ERA Feedback on the Partial Review of the Ta' Qali Action Plan (Phase 3)

October 2020

Figure 3: Mixed concrete paving and grass to enhance permeability aiding in rainwater storage.

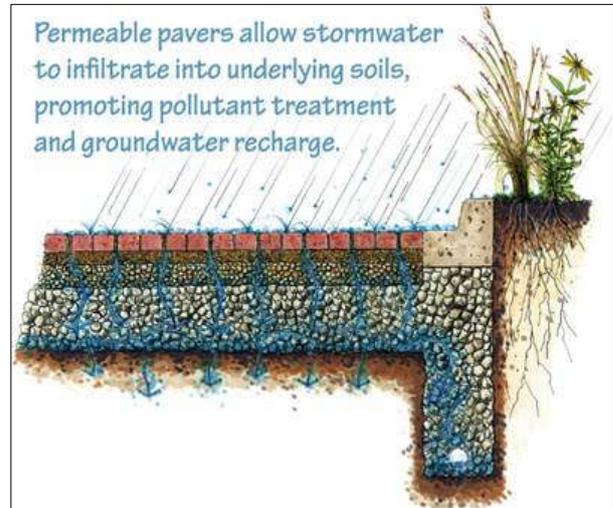
4. The proposed walkway itself could be designed as a permeable pavement, with the implementation of permeable paving as indicated in Fig. 3 & 4. This would add to the green element in the area whilst
